**BEFORE THE BOARD OF PATENT APPEALS
AND INTERFERENCES**

Application Number: 09/531,735

EXAMINER'S ANSWER

Claims 9-22, 33-35 are rejected under 35 U.S.C. 102(b) as being anticipated by Weber (3670413).

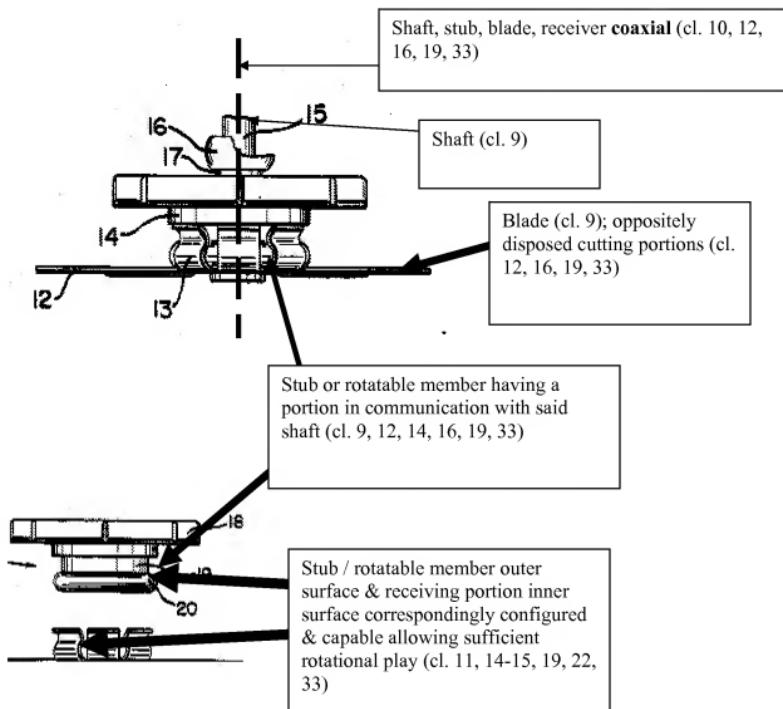
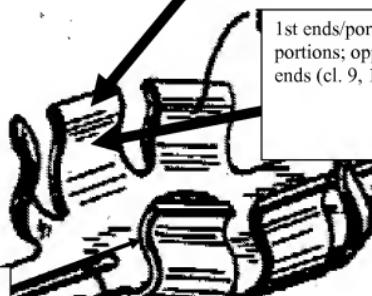
In support of the features described above and as claimed in the claims, Weber shows:

Blade body including platform
(cl. 12, 16, 19, 33)

Receiver coupled to the blade having flexible members & receiving portion (cl. 9, 12, 14, 16, 19, 33); the flexible members / bodies / spring clips with spring like behavior (cl.13, 17, 20, 34); retaining forces to be greater than the rotational forces of the blade (cl. 35)

2nd ends/portions, force/pressure acting thereon moves the engaging portions/first portions outward, which allows disengagement of the stub (cl. 9, 12, 16, 19, 33)

1st ends/portions & engaging portions; opposite of the second ends (cl. 9, 12, 16, 19, 33)

Protrusions (cl. 33)

Grooves (cl. 33)

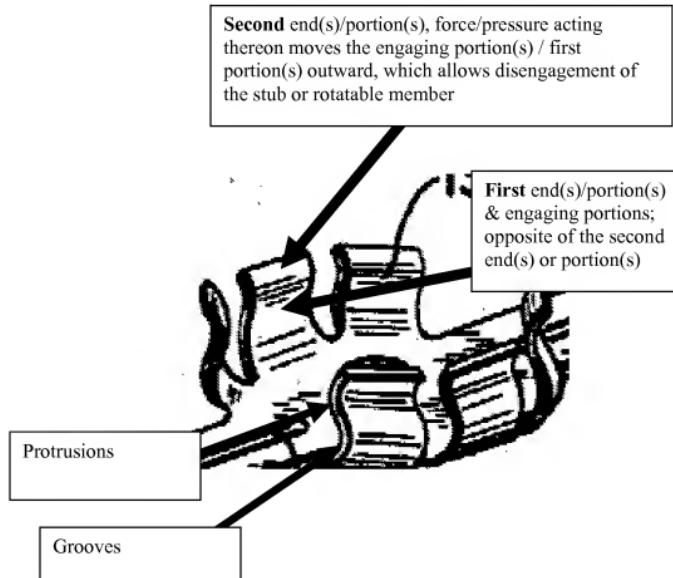
Appellant argued and labeled the free upper end of the spring clips 13 as the first end, and the lower end as the second end.

However, this is contrary to the interpretation and how the Examiner applied the reference in view of the claims as they were presented.

Thus, the Appellant is applying the force or pressure at the wrong end(s) or portion(s). In other words the Appellant suggests to apply force at a "static end" of the clip, which is contrary to the interpretation of the Examiner provided in the rejection.

The second end(s) or portion(s) the Examiner considered in the rejection is the upper area as shown in the marked up figures, whereas the first end is an opposite (lower) portion of the spring clips, and it is nowhere where the Appellant suggested, i.e. the wrongly labeled "static end of the clip" or "second end." In fact, as shown in the marked up figure below, the first end is not only not the "free end" of the spring clips, but it is not even at the place suggested for the

“second end.” Instead, the first end(s) or portion(s), which is opposite the second end(s) or portion(s), is as shown in the marked up figure, so the first end can move outward and release the rotatable member when force or pressure is applied to the opposite upper / second end(s) or portion(s).
